**Master Development Drainage Plan  
For  
THE RANCH**

**November 2018  
Revised May 2019**

SKP – 18-213

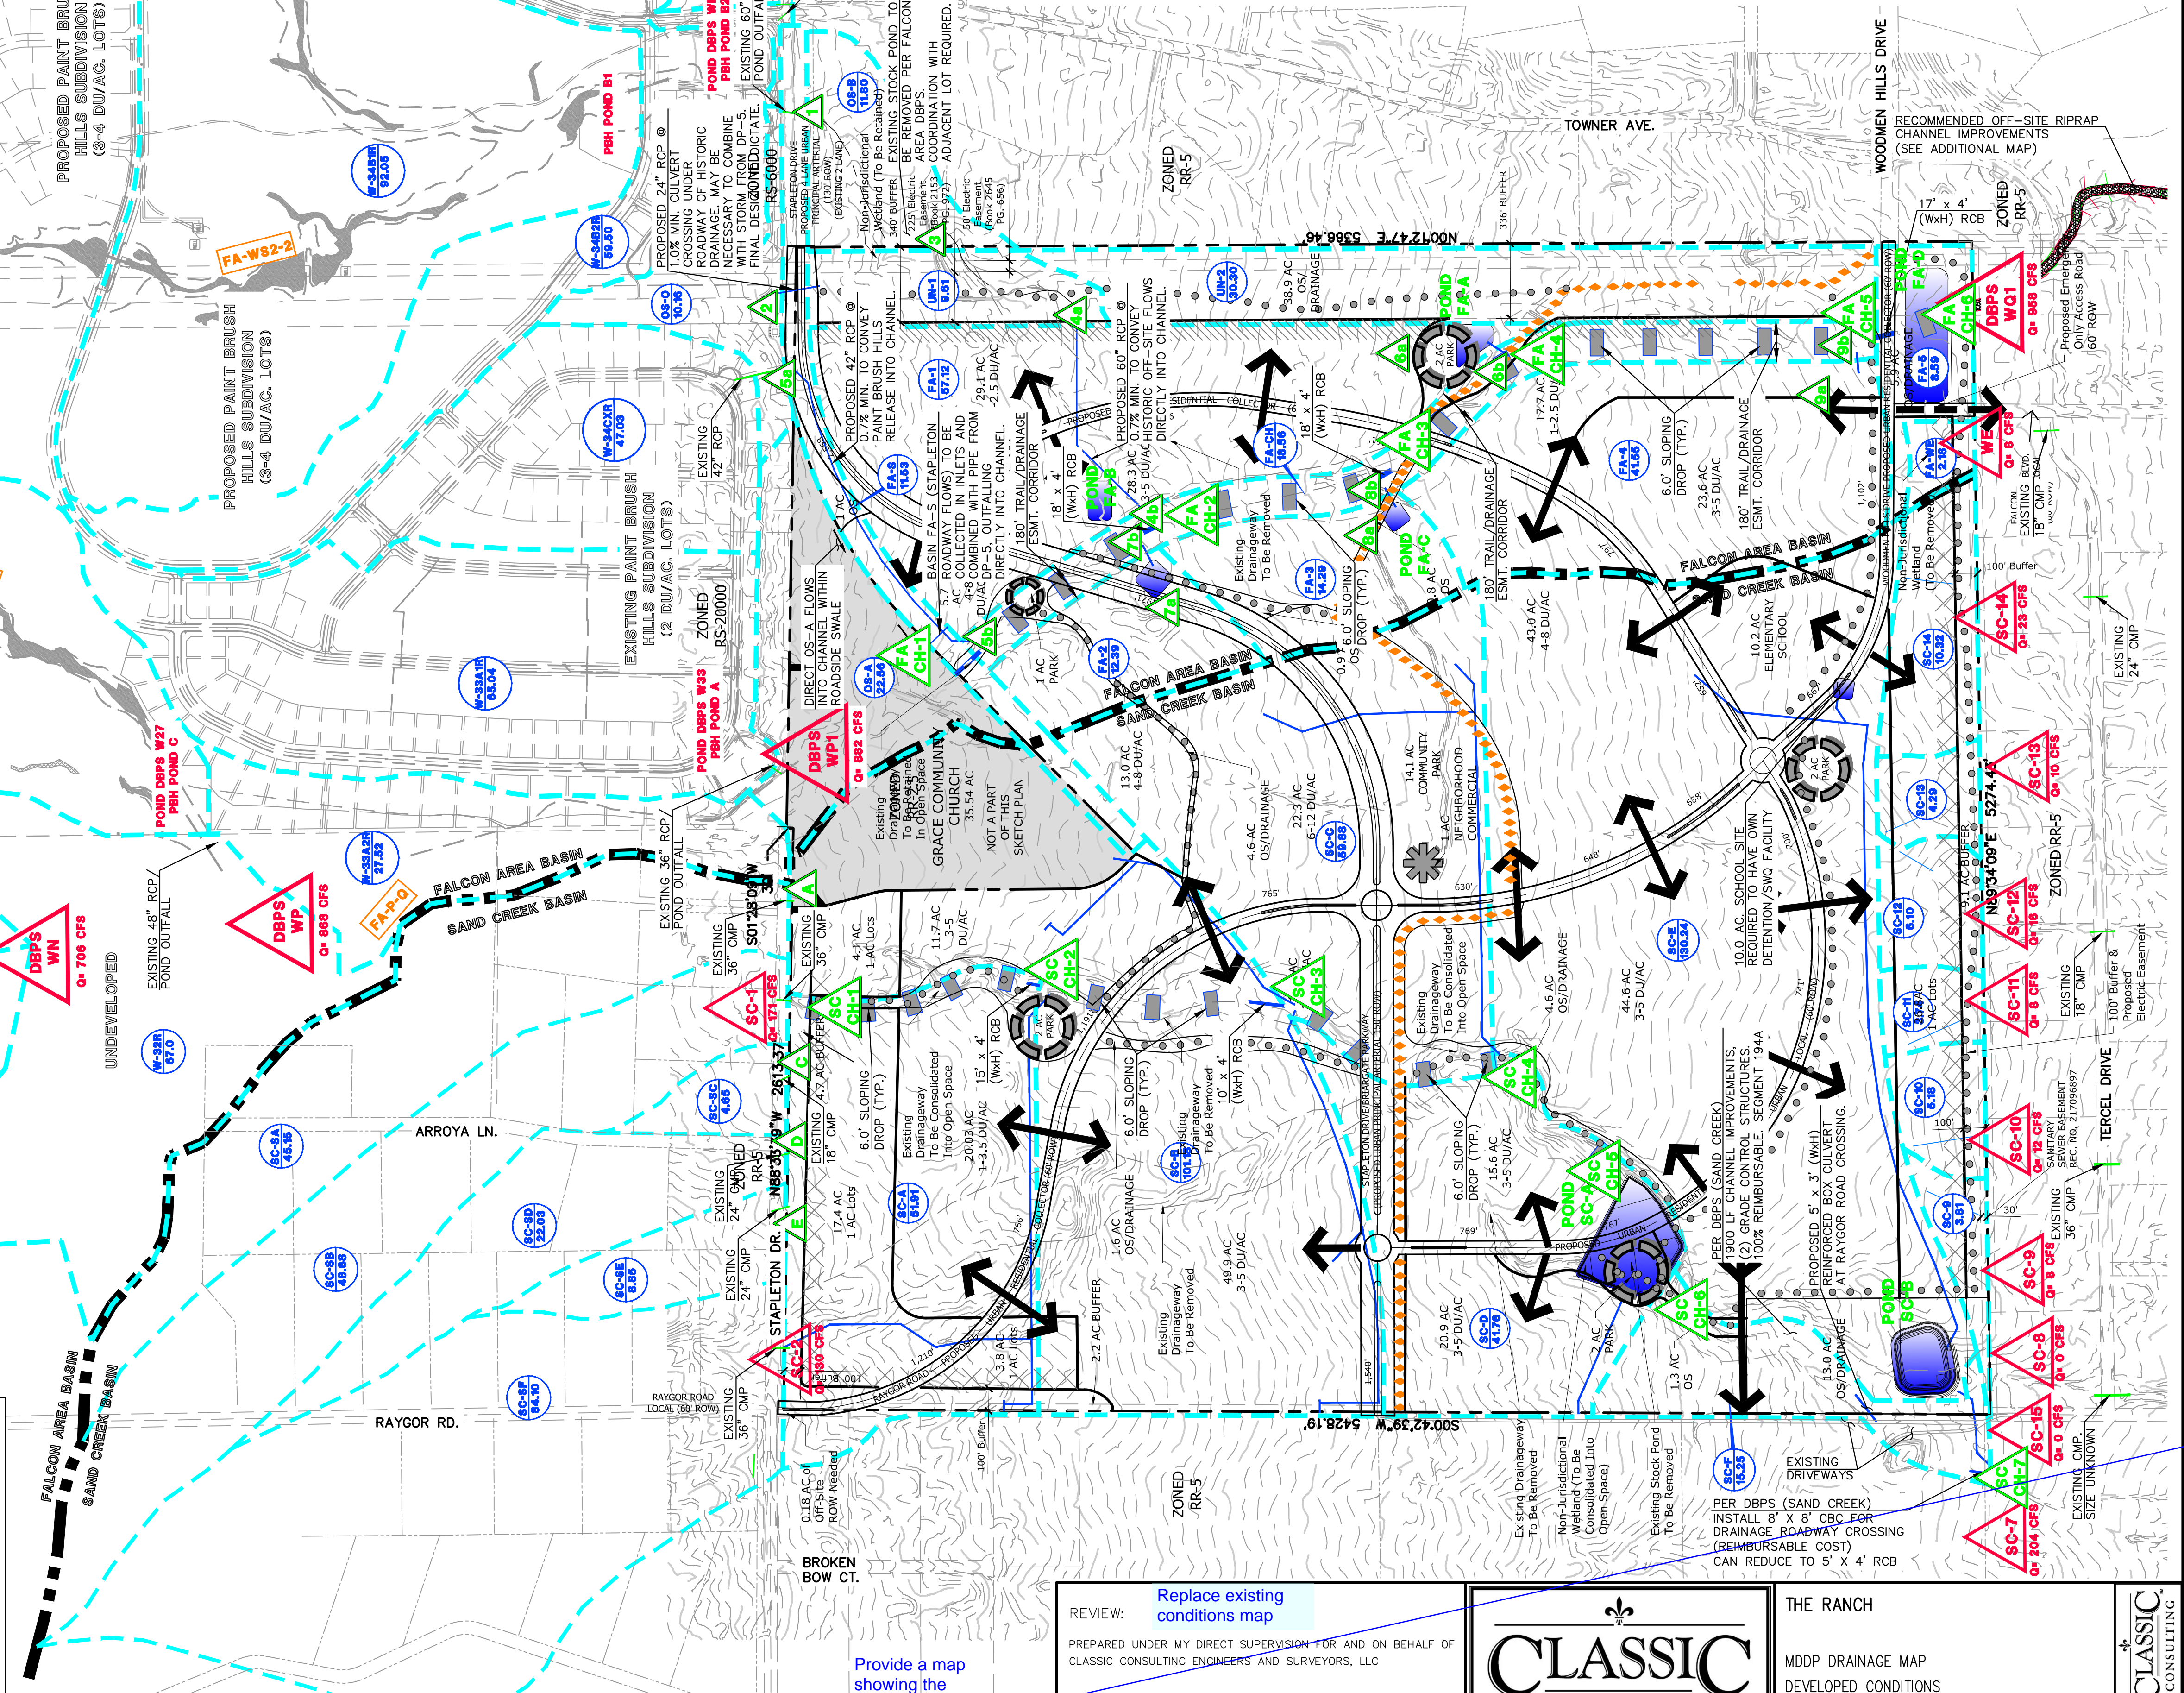
REVIEW: Replace existing conditions map
